Subject: RE: Cascade Chr CF&G

ENGINEERS RESPONSE TO JAMIE CARTER EMAIL 2024.08.16

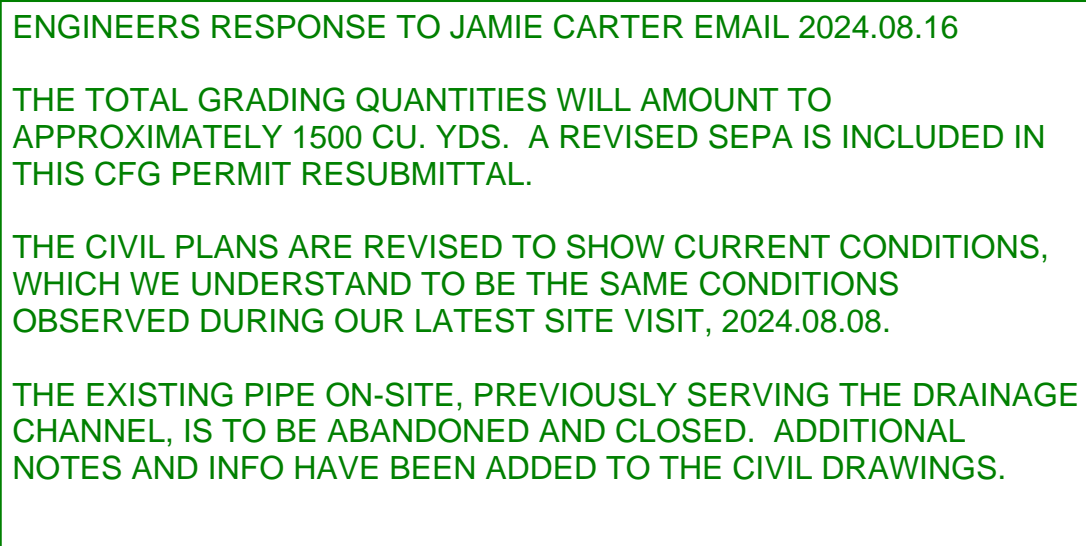
Also there was a channel that connects to a large storm pipe right next to the work. The channel is gone but the pipe (shown in green) is still there and is an open grate. CF&G plans call for protection, but there was none. Please address the permanent status of this drainage feature during civil review and construction. It has a direct connection to the city's system and the area around it has changed.

THE EXISTING PIPE ON-SITE, PREVIOUSLY SERVING THE DRAINAGE CHANNEL, IS TO BE ABANDONED AND CLOSED. ADDITIONAL NOTES AND INFO HAVE BEEN ADDED TO THE CIVIL DRAWINGS.

EX. JR. HIGH SCHOOL BUILDING
 (33,062 SQ. FT.)
 FF=67.75

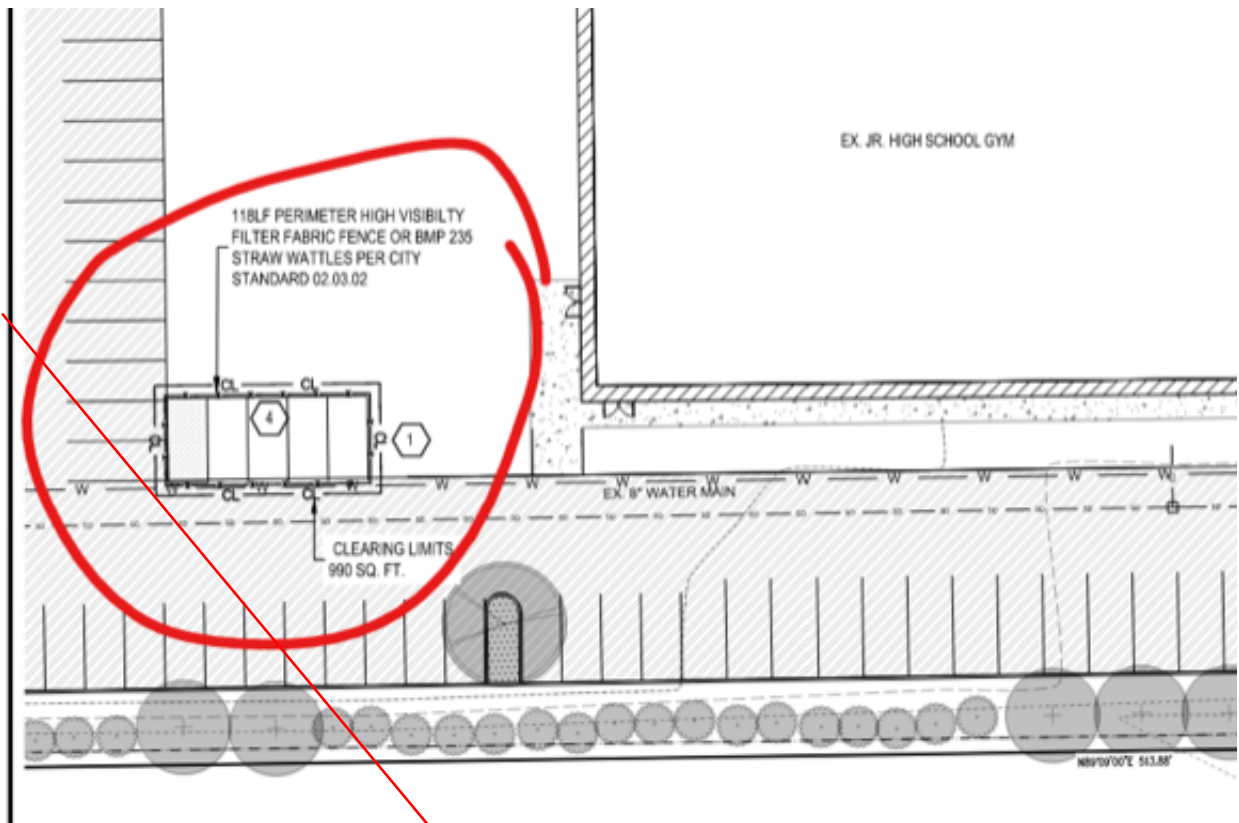
1. Sheet C3 says that parking to remain available during grading permit, but the other note says high visibility filter fence all around. Which is it? Is this area included to be sawcut or stripped of asphalt concrete under this CF&G permit. Bigger question for the civil: how will the portables sit half on and half off of the curb. I don't see any notes to demolish the sidewalk or to somehow support the south end of the portables at the same level of the sidewalk.
2. If we approve this round, I will strike out the street light details as they are not include din the CF&G work. Bigger question for the civil: Are street lights being installed? If so, we do not allow new installations on existing poles and my google map street view shows that one of them already has a street light on it.
3. The 118 LF fence here is for what?

- Are the proposed parking spaces to the east of the high school being graded out or worked on at all under the CFG permit? It doesn't say anything except that it should be surrounded by High Viz fence. What work is taking place?

1. That designation of the 2- portable area south of the high school could be improved.. We probably should have labelled it "Work Area" or "Impact Areas or something more precise. The High Vis Fence on the South side of the high school should be between all around the tree protection areas not the 'Clearing Limits' so the arrow should have extended farther up the page.

The strip of landscaping north of the walk does need to have the topsoil stripped down to mineral soil so the piers closest to the high school building are resting on something solid (portable supplier specs 2500 PSF).

The rest of that "Clearing Area" is not to be demolished of concrete and asphalt, as the portables have piers on post foundations that will be shorter or longer depending on which surface each pier is over. The parking should remain until the Civil Permit, when more parking will come on line.

2. Yes, please strike out the lighting, that was a civil permit item inadvertently included. We are hopeful that the existing pole mounted lighting on 21st will be determined suitable, which was the initial screen during pre-app. However, since the client has asked us to pre-do iterations of plan sets based on various potential scenarios raised by the SEPA process, we have started design on several things that will probably prove extraneous.

3. That 118 LF is the perimeter of the topsoil stripping and subgrade prep for a 4 stall parking bay that should be active through Phase 5 to meet the parking minimums. The Box on the west side of those 4 stalls is a landscape island to meet the parking code, so needs to have the soil amendment there.

4. The prep to upgrade the East 2 bays of gravel parking to future code-compliant parking is a grey area between this and the Civil permit. We put it on the CFG to give the best indication of potential soil disturbance we can. The contractor has been asked to pothole and confirm the gravel thickness, If they find any thin or soft spots (such as occur under dried up mud puddles) they need to excavate and rehabilitate, and generally dress grade the surface in prep for future asphalt under the civil permit.
